TRANS/WP.29/2005/41
7 April 2005

PROPOSAL FOR DRAFT SUPPLEMENT 4 TO 02 SERIES OF AMENDMENTS TO
REGULATION No. 30

(Pneumatic tyres)

Transmitted by the Working Party on Brakes and Running Gear (GRRF)

Insert a new paragraph 3.1.12., to read:

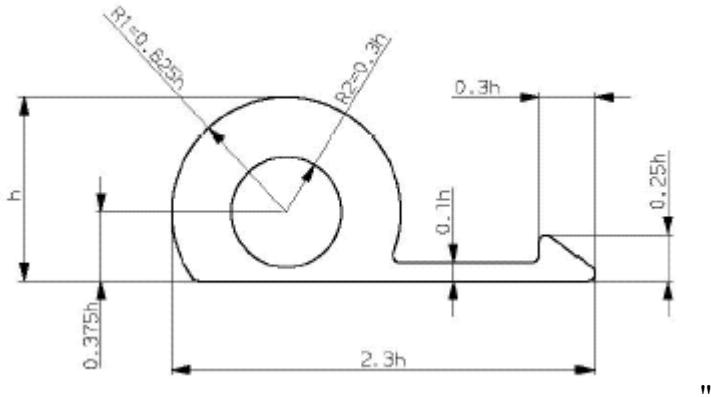
"3.1.12. The symbol below if the tyre is a "run flat" or "self supporting" tyre, where "h" is at least 12 mm.
